Internal Referral Brief for MPRG

SUBMISSION TO MAJOR PROJECT REVIEW GROUP

AGENDA ITEM NO.	
DATE OF MEETING	
SUBJECT	DA 201629628 – BLOCK 4 SECTION 41 LYNEHAM
BRANCH	DEVELOPMENT SERVICES
PRESENTED BY	AJITH BUDDHADASA

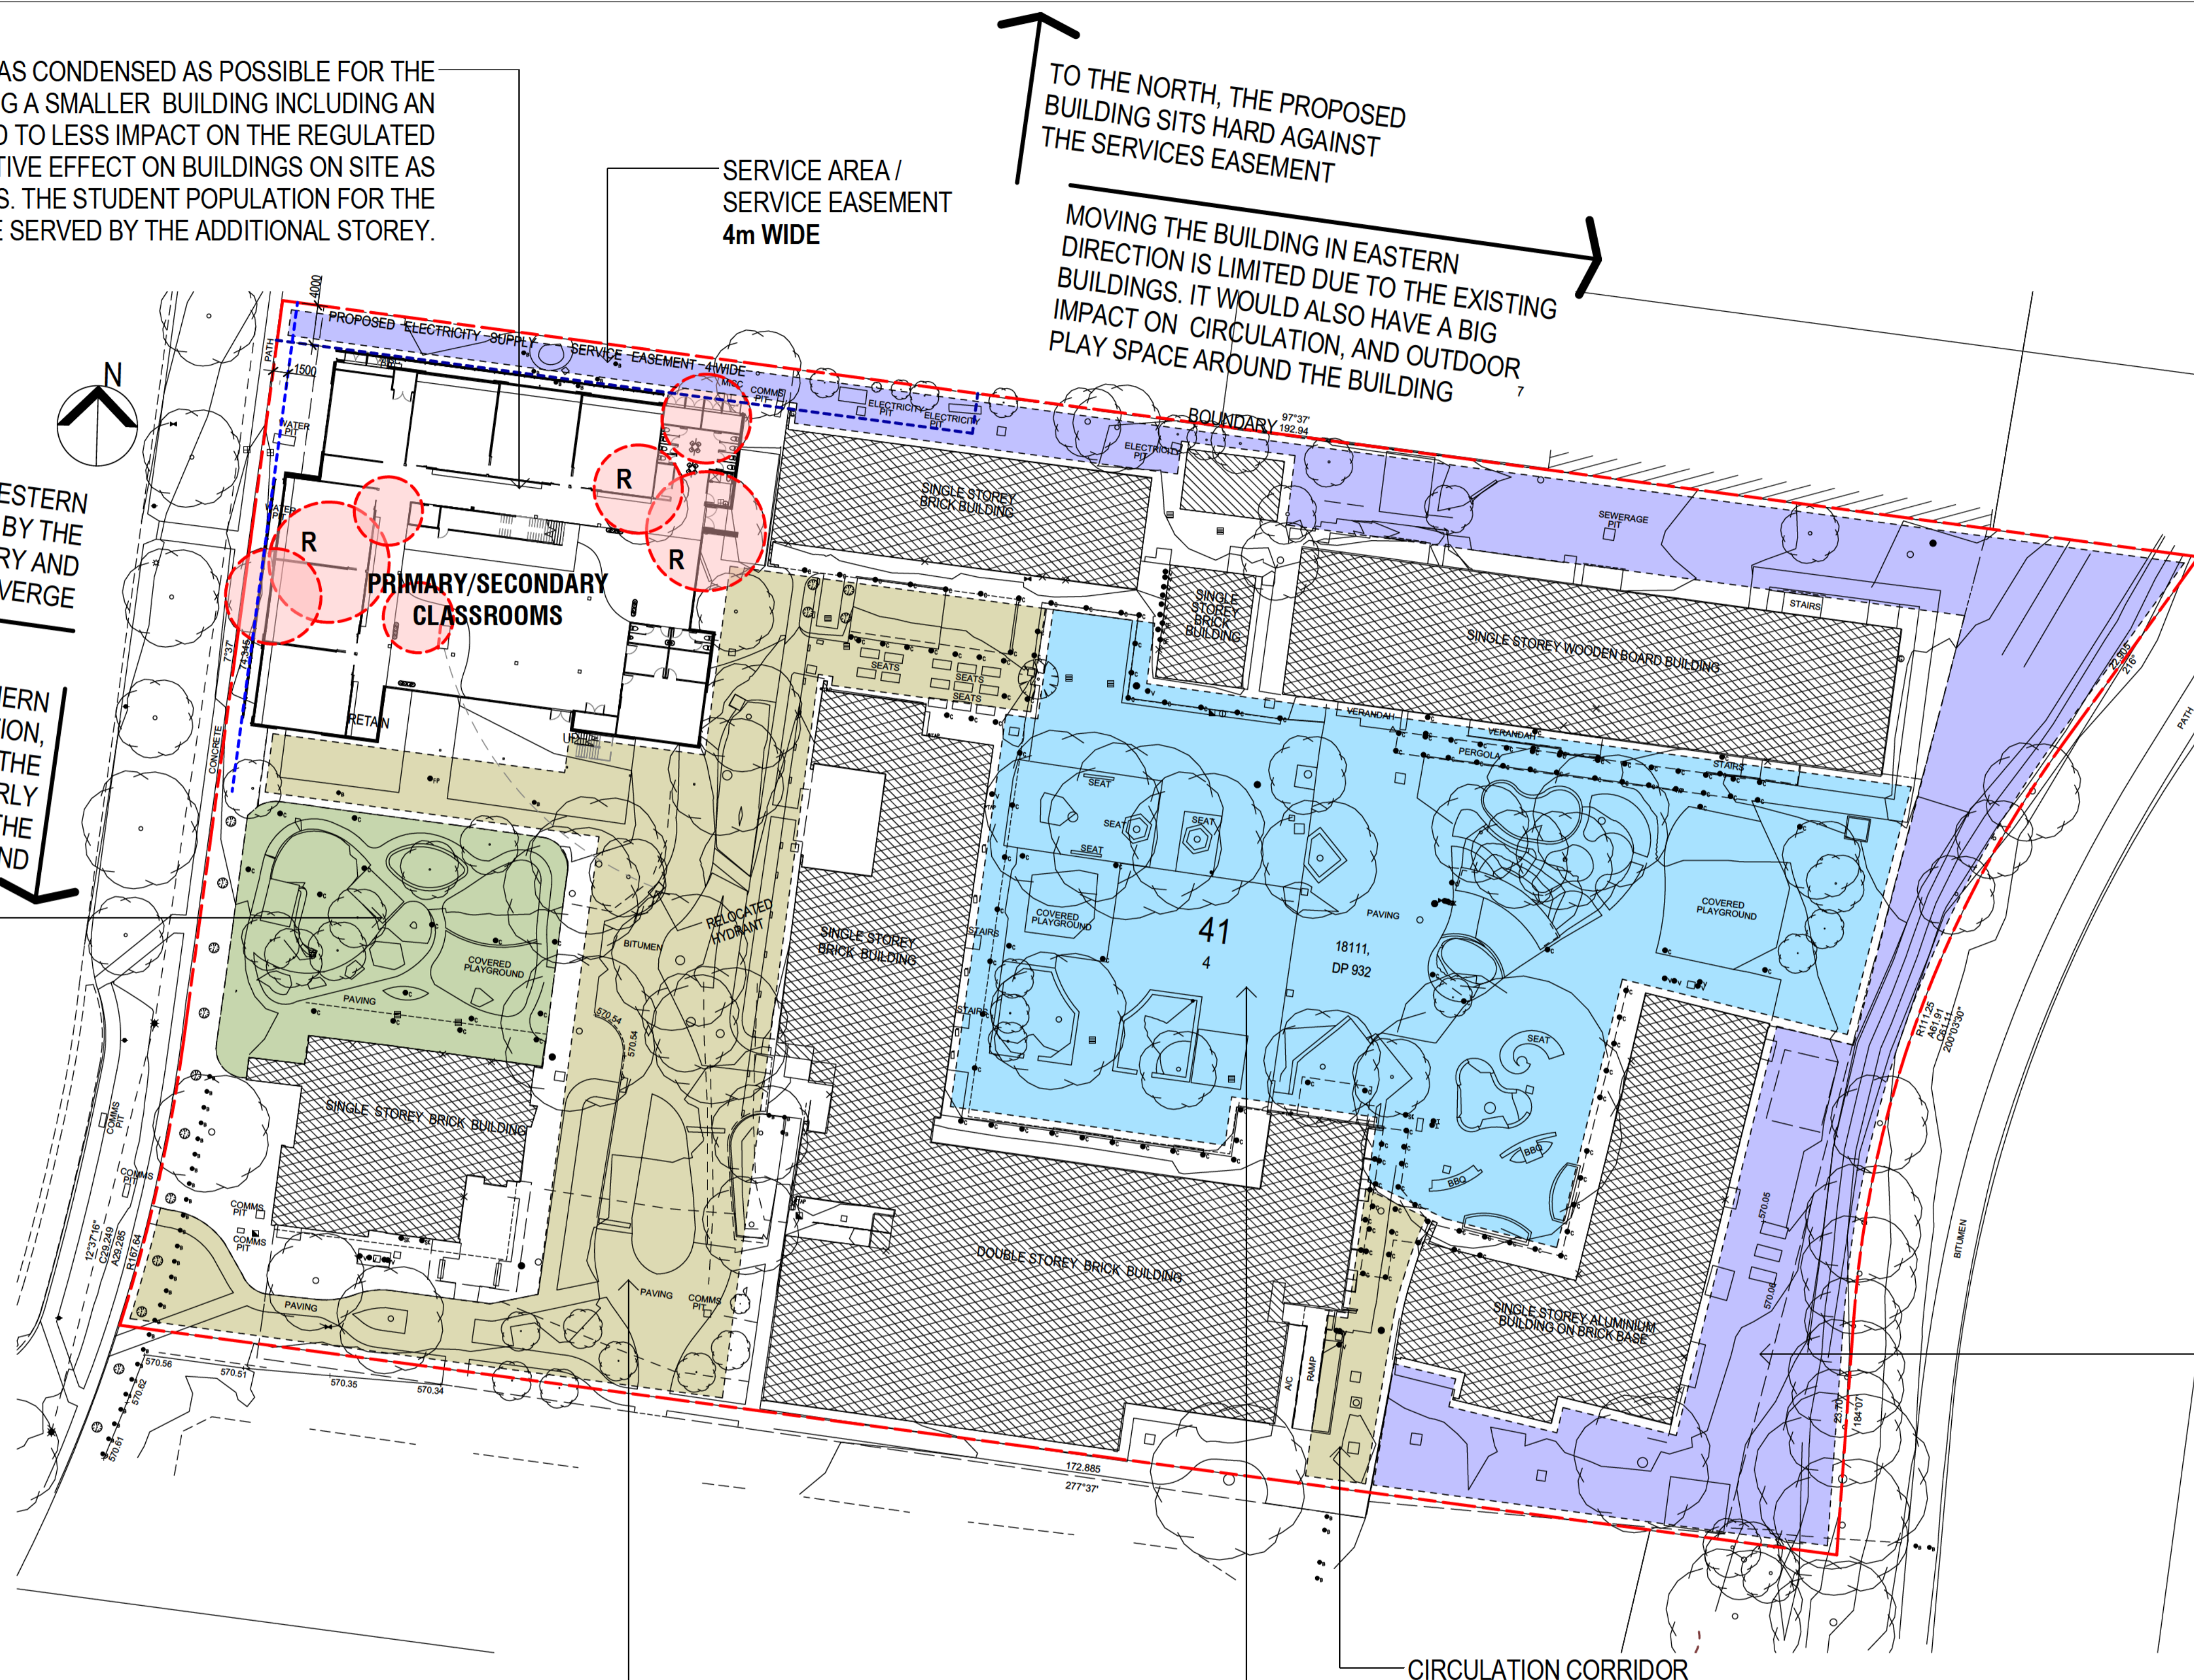
MOVING THE BUILDING IN WESTERN DIRECTION IS RESTRAINED BY THE CLOSENESS TO THE BOUNDARY AND THE ELECTRICAL POSTS IN THE VERGE

MOVING THE BUILDING IN SOUTHERN DIRECTION WOULD LIMIT CIRCULATION, AND OUTDOOR PLAY SPACE AROUND THE BUILDING, AND NEGATIVELY ON THE EARLY LEARNING CENTRE AND THE REQUIREMENTS FOR ITS PLAYGROUND
